From: [REDACTED]
To: [REDACTED]
CC: [REDACTED]
Sent: 2/23/2021 3:00:52 PM
Subject: RE: O8W-PM [REDACTED] Bucks Creek 1101 Phase 1,2&3 - Pre-Engineering Meeting

Subject: O8W-PM [REDACTED] - Bucks Creek 1101 Phase 1,2&3 - Pre-Engineering Meeting

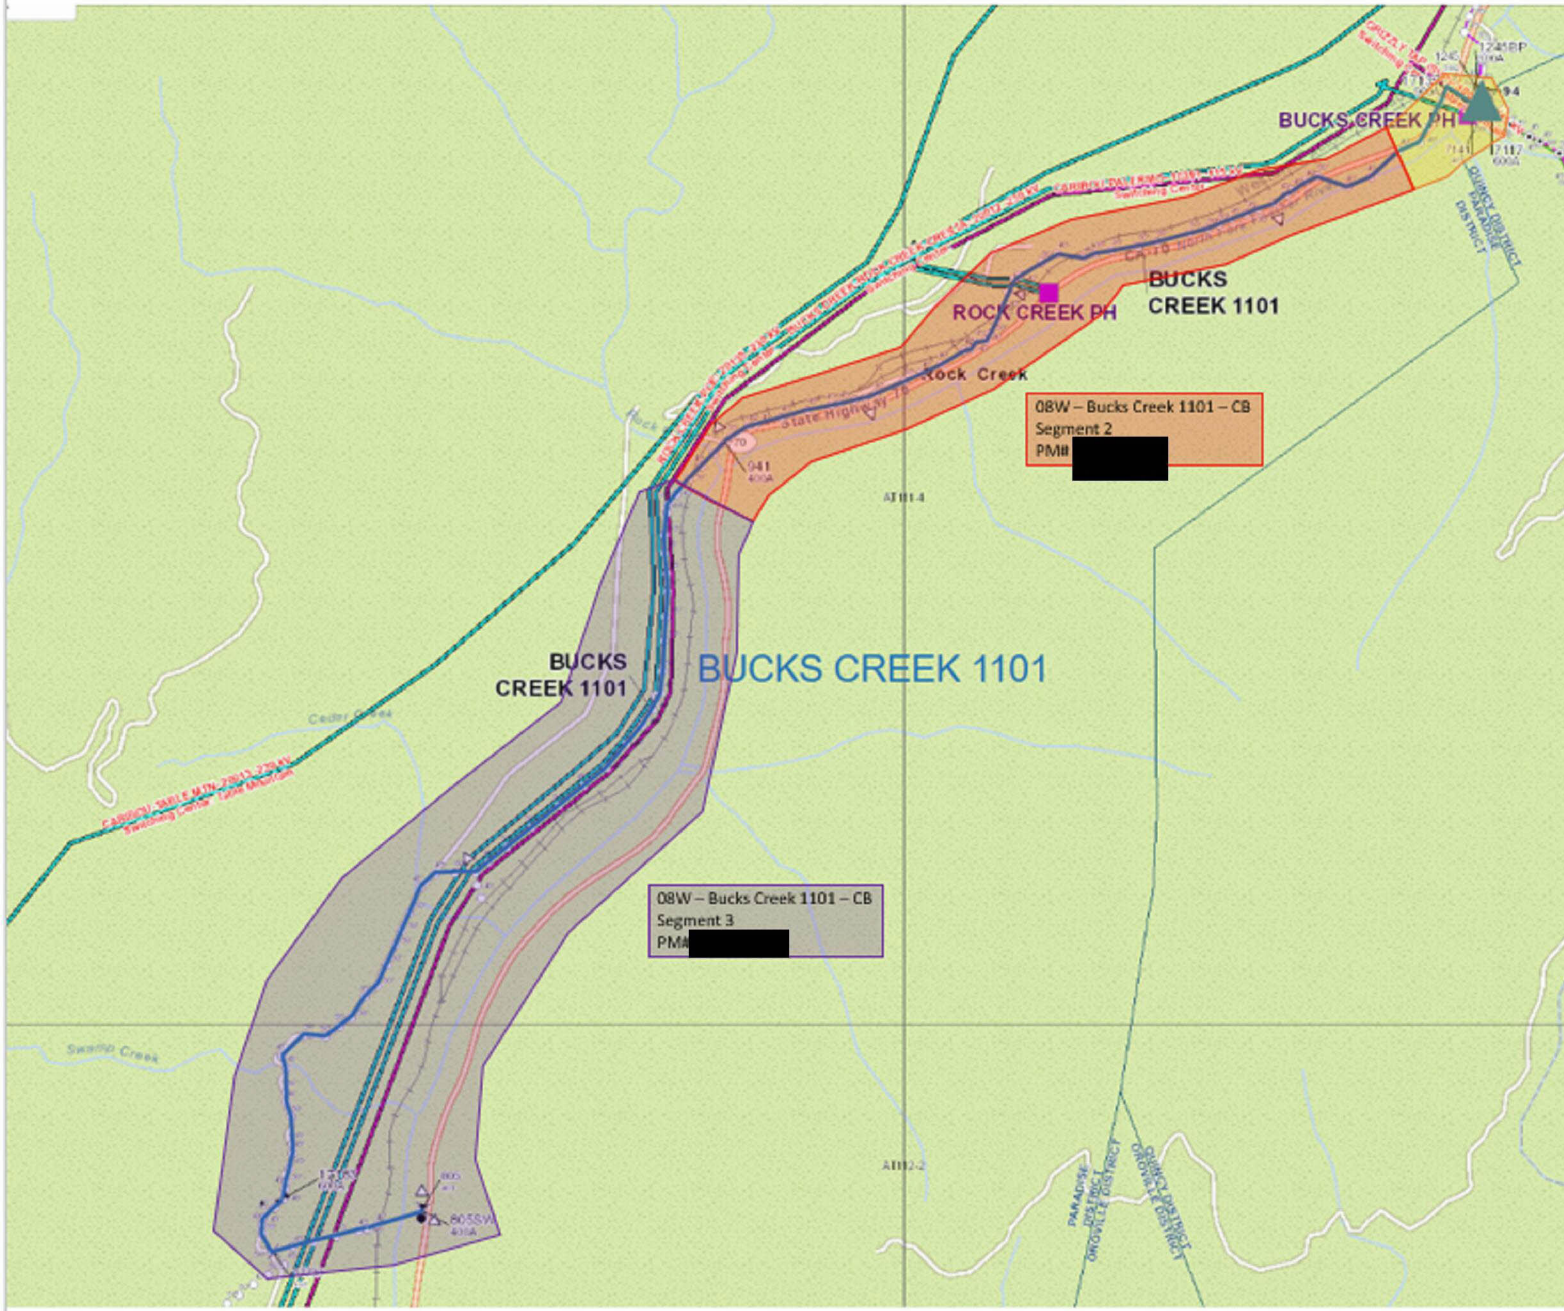
Attached are the 'base-map' limits in a kmz. file. As you will see, we need our base-map to go about ~100' into the tunnel at the south end (see pedestal in picture below....please begin about ~50 beyond this point which is about ~100' beyond the Cresta Dam).

We want to end the base-map at the sign location below which is roughly at MM (Mile Marker) 5.10.
